Ref: 5057-S92

Re: 22 & 22A Summit Drive – LUC60456483 Response to Auckland Council’s s92 Geotechnical Queries

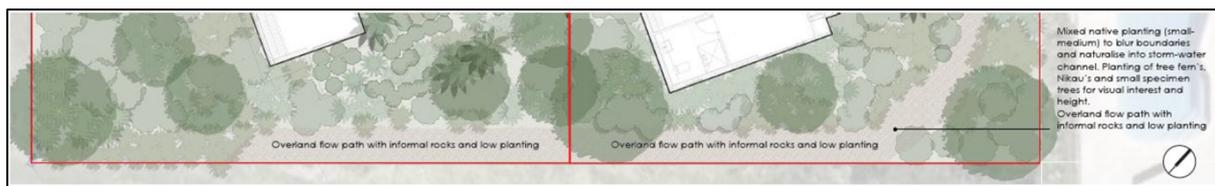
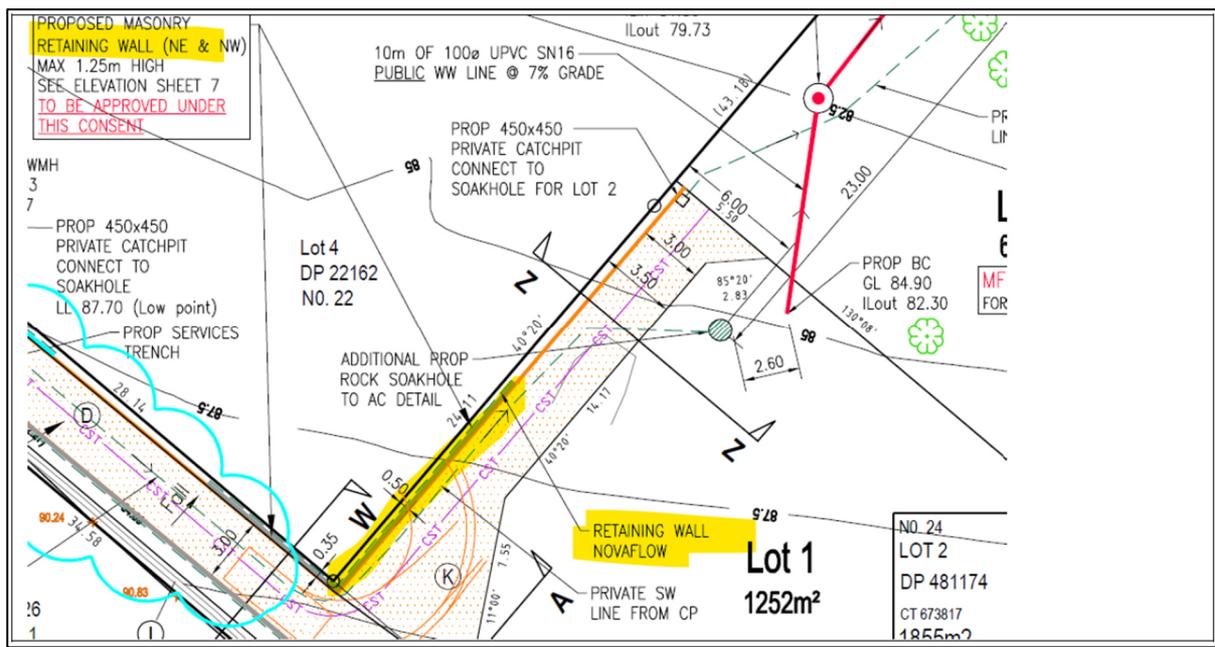
However, the applicant has provided calculations for this OLFP. Based on the flood risk management guideline of the Australian Disaster Resilience Handbook Collection (see below for chart), it is considered that the maximum flood depth and velocities to be H5, which is identified as unsafe for vehicles and people.

The assessed peak velocity within the OLFP is 2.60 m/s on slopes steeper than 1:3. Informal rock placement and planting are unlikely to provide adequate erosion resistance at this velocity. The applicant's geotechnical engineer is encouraged to check that concentrated surface flows and any excavation/structures do not reduce slope stability (global and local), including for potential undercutting and loss of support near boundaries/driveways/retaining walls for neighbouring properties."

GeoStudio's comments: Please note that assessing the scoring potential of land/retaining walls at a certain OLFP velocity is outside the expertise of a general geotechnical engineer experienced in geomechanics. We provide the following general comments in regards to slope stability: Refer to our response to Item 7. The site is no steeper than 1V:3H. Surface water created by the OLFP may reduce

the short term stability of the slope, but this has already been considered as part of the risk assessment of the elevated groundwater condition for slopes which are no steeper than 1V:3H in certain geological settings. It is therefore our opinion that the overall slope stability of the site, even considering the OLFP is acceptable.
